10 Mb/s Single Twisted Pair Ethernet 10BASE-T1L PHY State Diagram Changes

Steffen Graber
Pepperl+Fuchs

PCS Receive State Diagram (part a) Changes

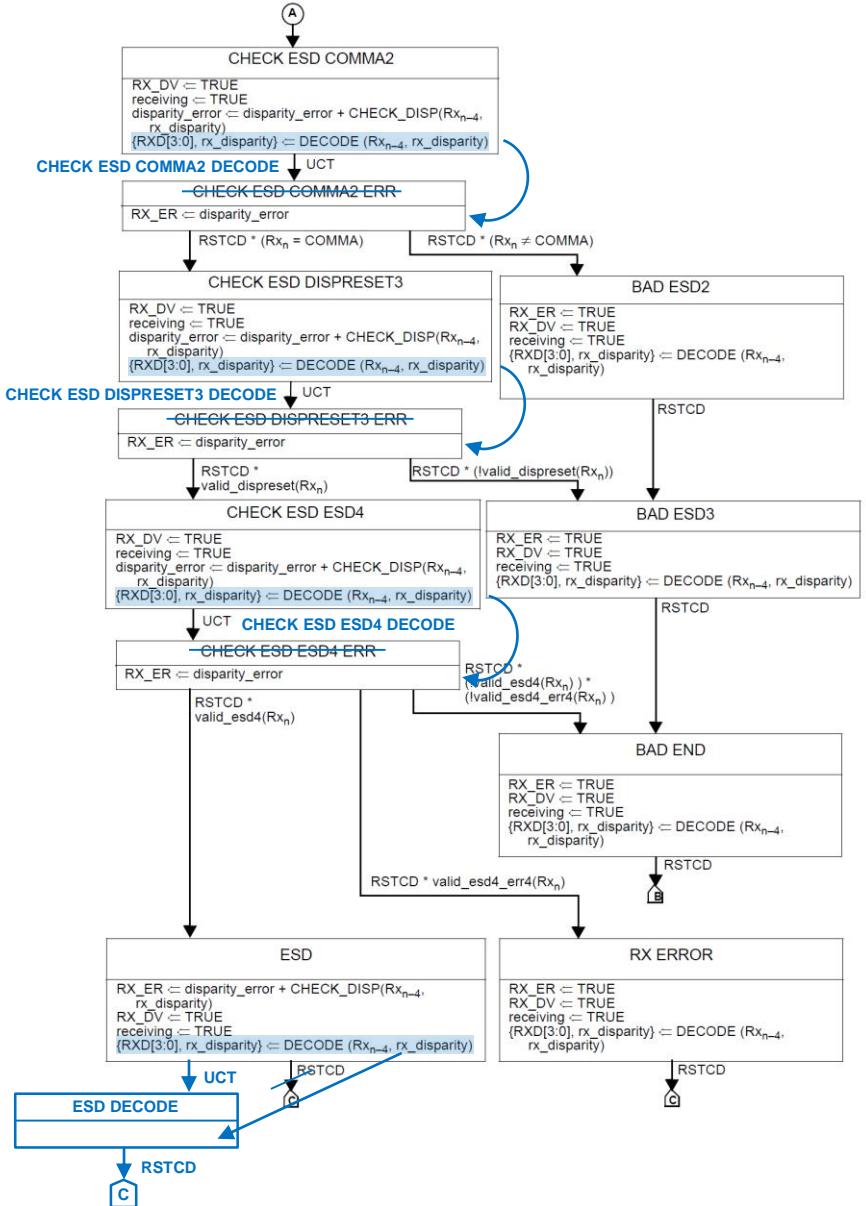
- Change exit conditions of IDLE state to be mutually exclusive (comment r01-61), marked in **orange and italic**.
- Avoid ambiguity when a variable (rx_disparity) is set and used in the same state (comment r01-62), marked in **blue**.
- This change is only for clarification, there is no change in the behavior of the state diagram.

PCS Receive State Diagram (part b) Changes

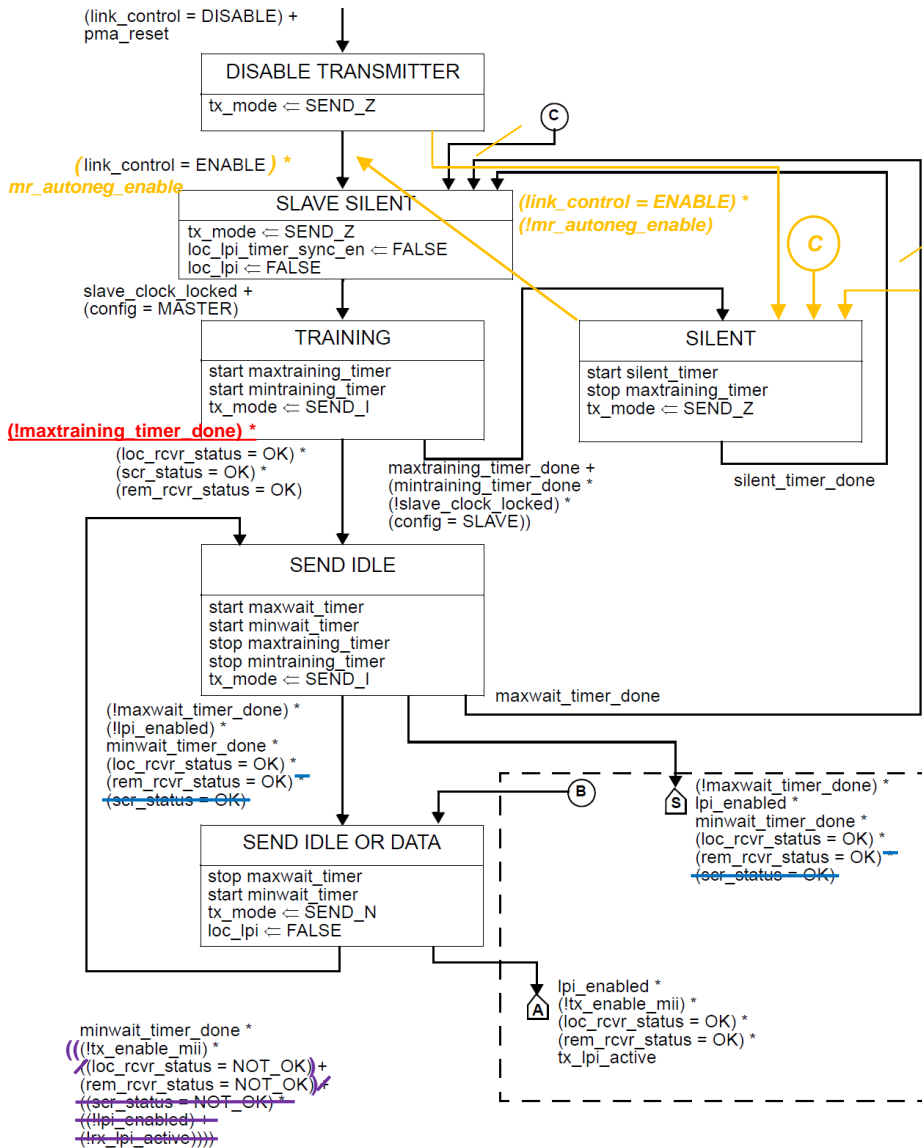
- Avoid ambiguity when a variable ($rx_disparity$) is set and used in the same state (comment r01-62), marked in blue.
- This change is only for clarification, there is no change in the behavior of the state diagram.

PHY Control State Diagram (part a) Changes

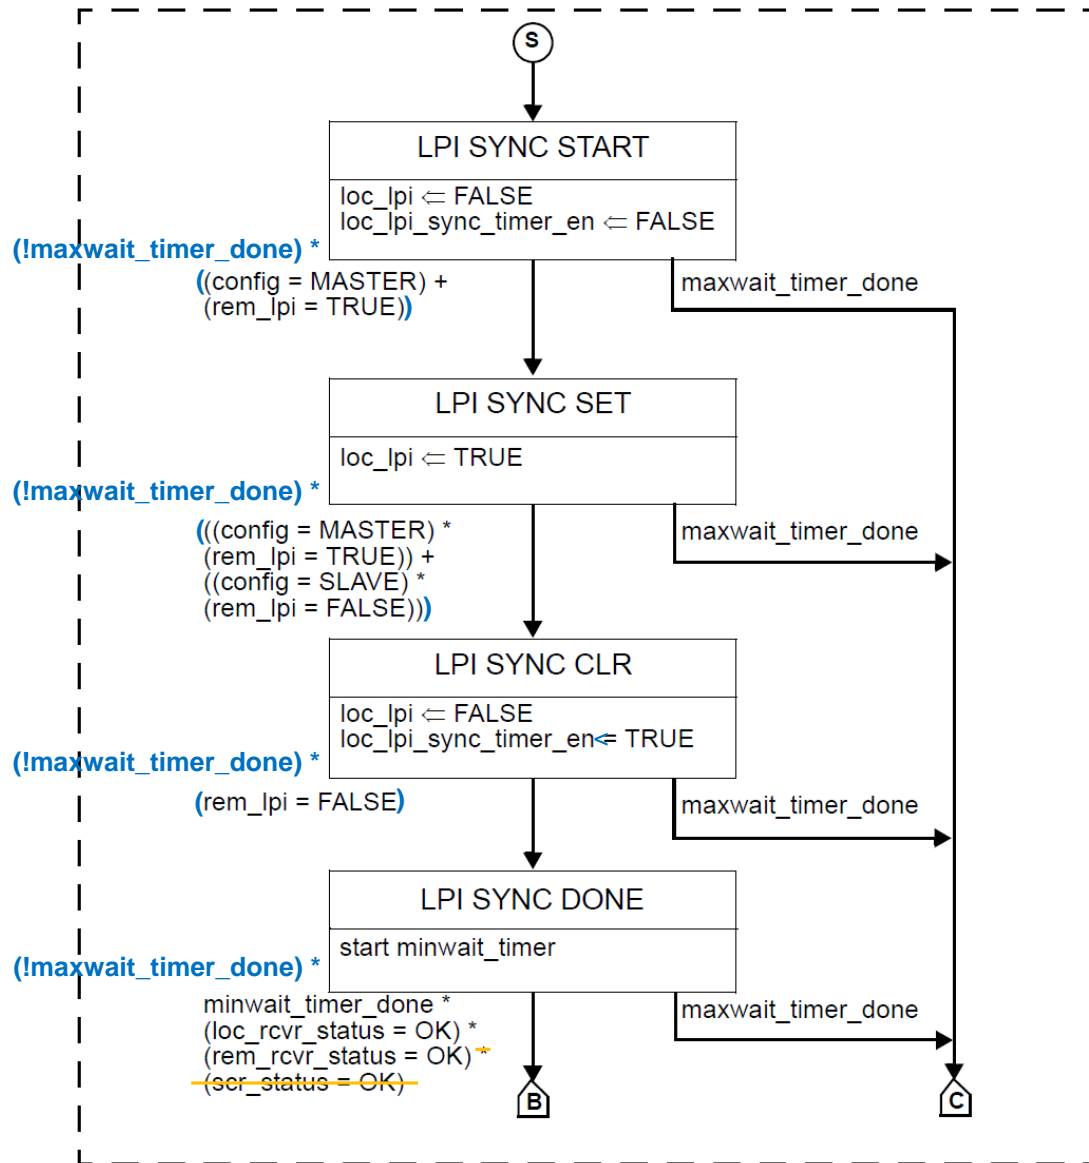
The **orange and italic** marked changes around SILENT and SLAVE SILENT state are necessary to resolve the problem of not reliably breaking the link, as described on page “PHY Control Training Synchronization” (comment r01-64).

Adding the **(!maxtraining_timer_done)** condition **(in red and underline)** to the arc going from TRAINING to SEND IDLE provides a mutual exclusive condition in relation to the second exit condition of the TRAINING state (comment r01-65).

The changes at the bottom left of the state diagram **(in violet)** are related to solving the issue described on page “PHY Control LPI Timer Synchronization” (comment r01-66).

Besides an initial checking of “scr_status” variable after TRAINING, in all other states this variable is not checked any more, as this would already assume some implementation specific details, which are out of the scope of the standard (marked in **blue**, comment r01-67).

PHY Control State Diagram (part b) Changes

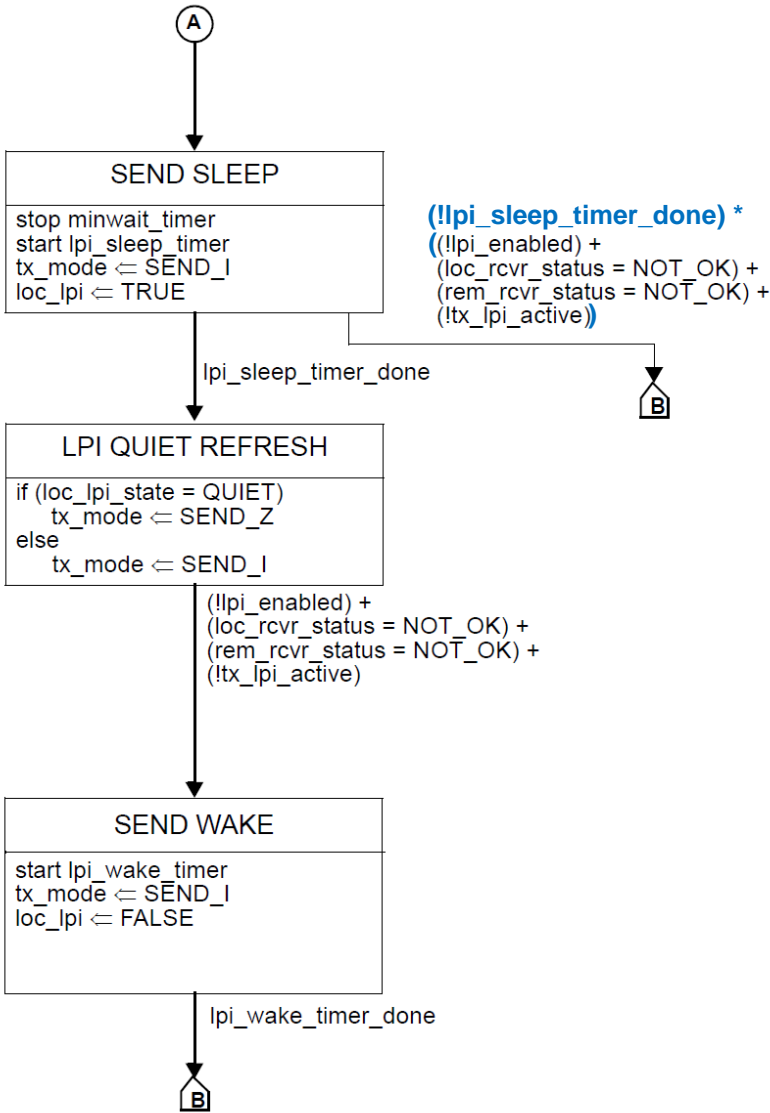
- Add `(!maxwait_timer_done)` conditions to generate mutually exclusive exit conditions of the states (comment r01-68), marked in **blue**.
- Remove `(scr_status = OK)` checking at the exit condition of state LPI SYNC DONE, as this is implementation dependent and out of the scope of the standard (comment r01-68), marked in **orange**.

P152, L8: On arc from LPI SYNC START to LPI SYNC SET, change condition from: "(config = MASTER) + (rem_lpi = TRUE)" to: "(!maxwait_timer_done) * ((config = MASTER) + (rem_lpi = TRUE))"

P152, L14: On arc from LPI SYNC SET to LPI SYNC CLR, change condition from: "((config = MASTER) * (rem_lpi = TRUE)) + ((config = SLAVE) * (rem_lpi = FALSE))" to: "(!maxwait_timer_done) * (((config = MASTER) * (rem_lpi = TRUE)) + ((config = SLAVE) * (rem_lpi = FALSE)))"

P152, L22: On arc from LPI SYNC CLR to LPI SYNC DONE, change condition from: "rem_lpi = FALSE" to: "(!maxwait_timer_done) * (rem_lpi = FALSE)"

P152, L27: On arc from LPI SYNC DONE to exit tag "B", change condition from: "minwait_timer_done * (loc_rcvr_status = OK) * (rem_rcvr_status = OK) * (scr_status = OK)" to: "(!maxwait_timer_done) * minwait_timer_done * (loc_rcvr_status = OK) * (rem_rcvr_status = OK)"
